REFERENCE No. L. M. A. 4950 OF 1928.

MEMO:—

PLAN SHOWING PROPOSED ADDITIONS & ALTERATIONS
TO HOUSE ON PLOT NO. 17 - SHEET J.L.5

With reference to ^{his}~~their~~ application dated 27.3.28 with a plan for the proposed Building additions on plot No. 17. Survey Sheet No. J.L. 5-
 Jail Quarter Mr. Harmandas Anandji is informed that until the following requirements are complied with the plans cannot be passed.

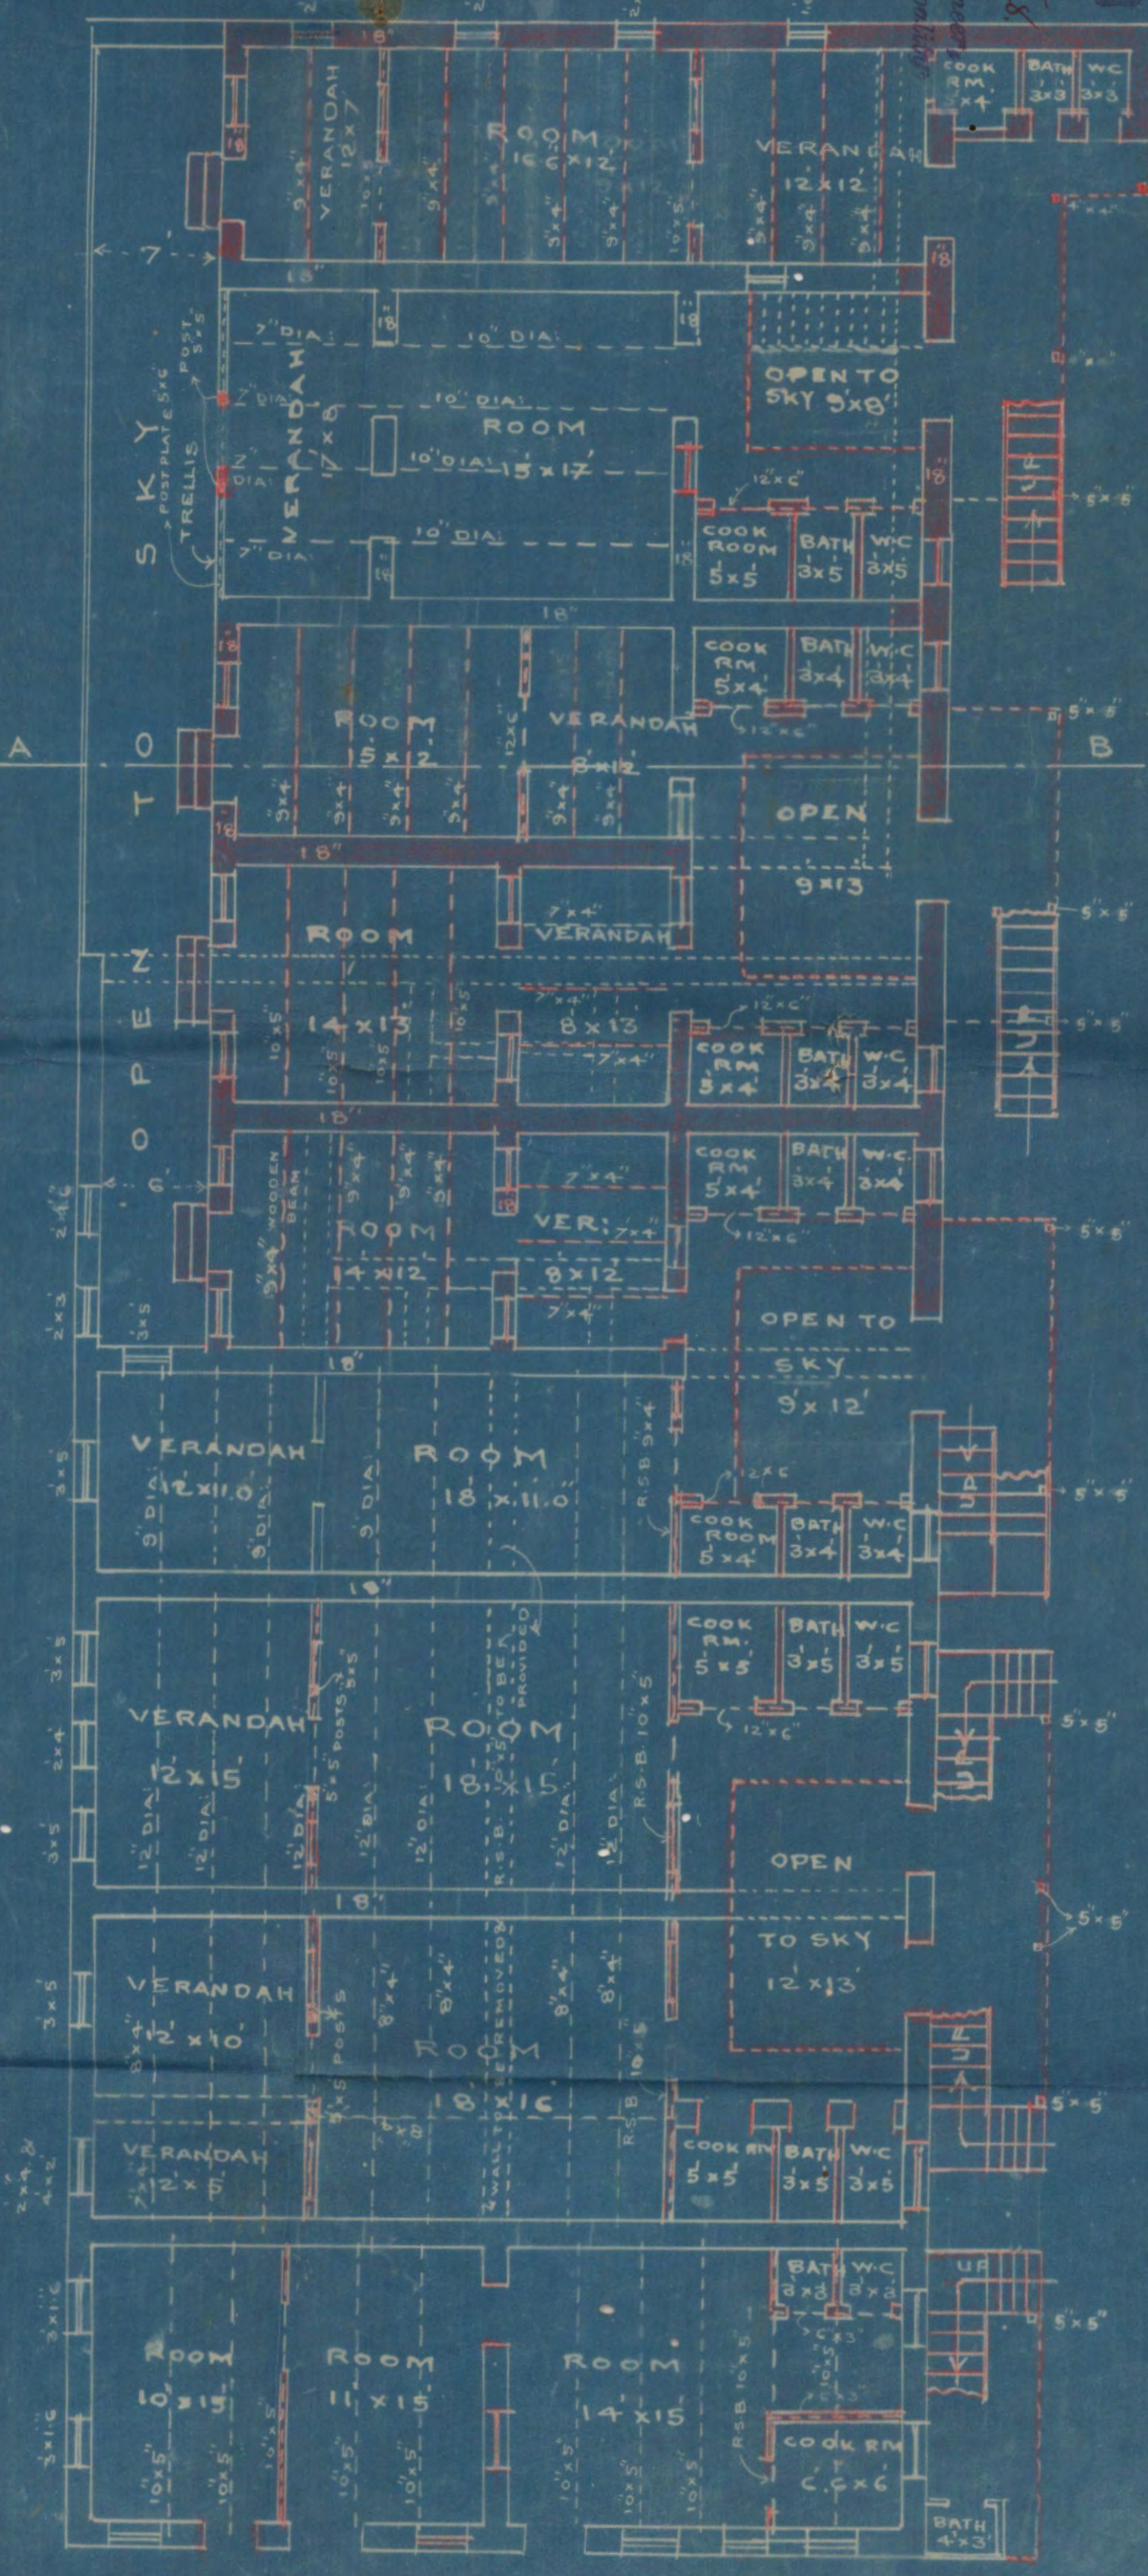
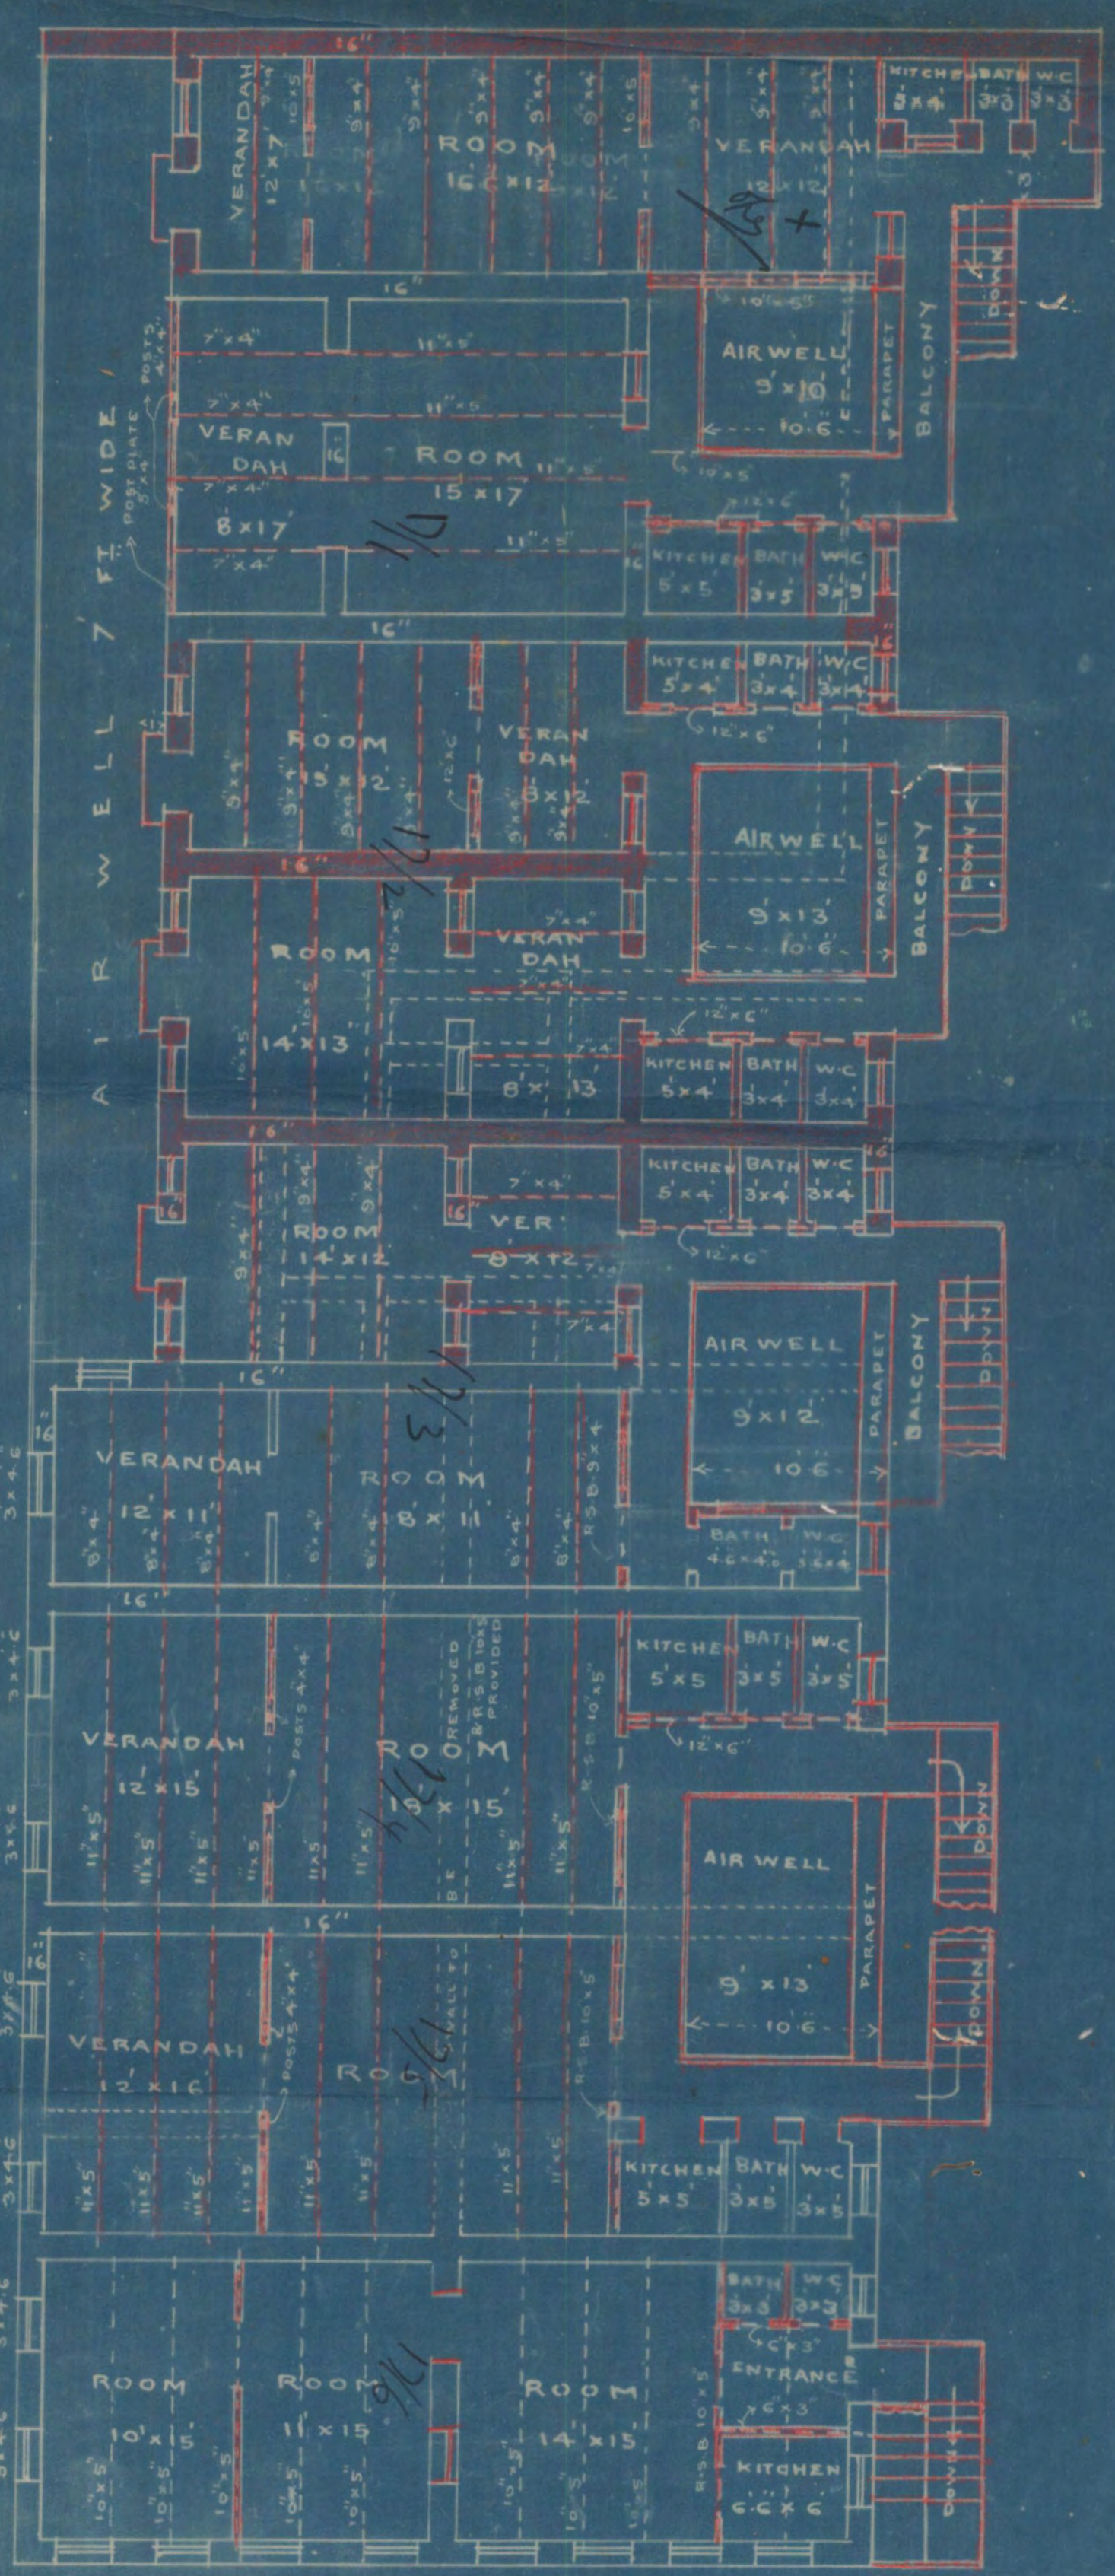
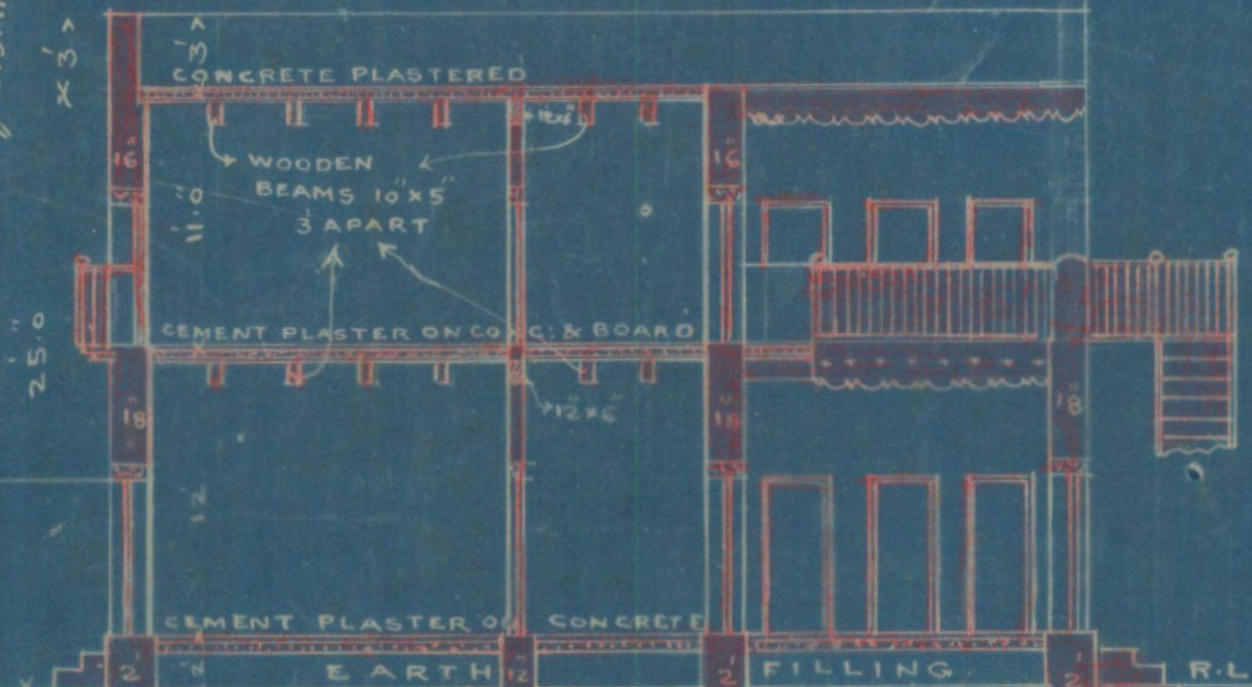
*No. objection
provided window
on 1st floor west side
kitchen window on
west side is left as
before & in plan*

(1) Windows on 1st floor of the flat abutting on Lady Dufferin Hospital side must be closed and this flat be provided with extra windows as explained to her, Khurji personally.

(2) Part of and Port plots be provided in place of 2 Counting from the Lady Dufferin Hospital side as shown in the accompanying plan.

(3) For the benefit of air and light of flat No. 6 the air well be increased as shown in the white print.

(4) The size of the joist be reduced or increased as per change made on the white print.

(5) No work be claimed for painting red.
